G.06 Open House #3 Comments and Feedback

From: Stanford, Jay
Sent: February 28, 2021 7:37 PM
To: [redacted]
Cc: Losee, Michael; Kittmer, Jane
Subject: Response to [redacted]
Attachments: CEMMP Update Discussion Paper 2020.pdf; City of London Landfill Expansion Wind Effects Evaluation_23Feb2021.pdf

TITLE
LANDFILL EXPANSION FINAL CONTOUR PLAN AND CROSS-SECTIONS

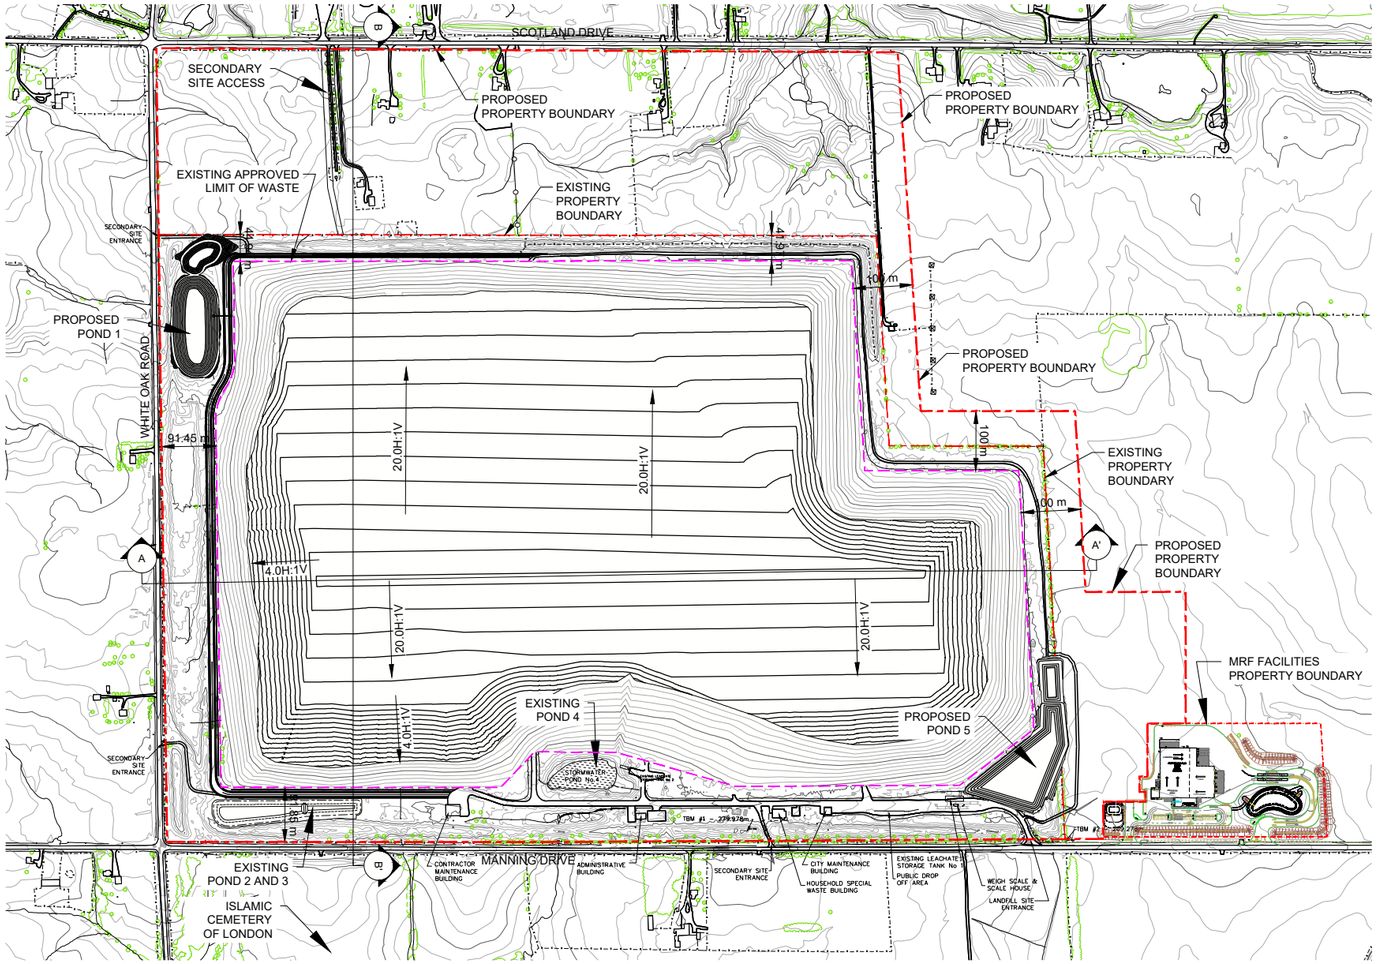
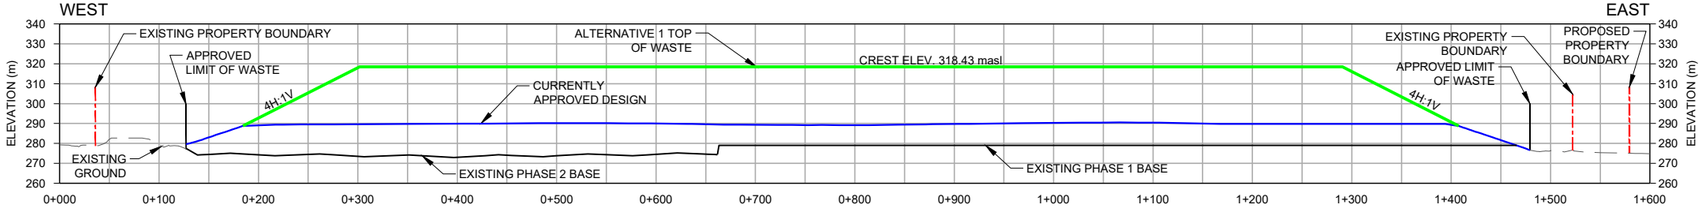
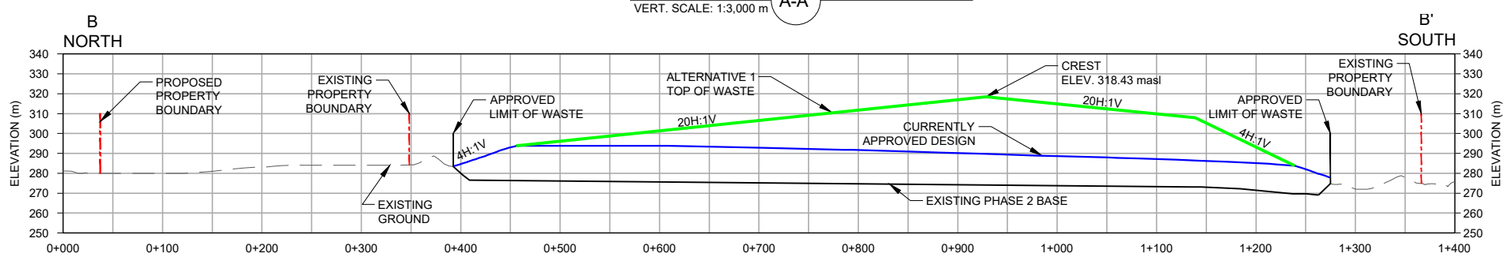
2. **The increase height of the landfill may change wind patterns and adversely impact the cemetery.**

Response. The analysis concluded that the cemetery is located outside the highly turbulent region where wind effects induced by the landfill expansion are likely. Consequently, the landfill expansion is unlikely to have significant effects on wind flows at the cemetery.
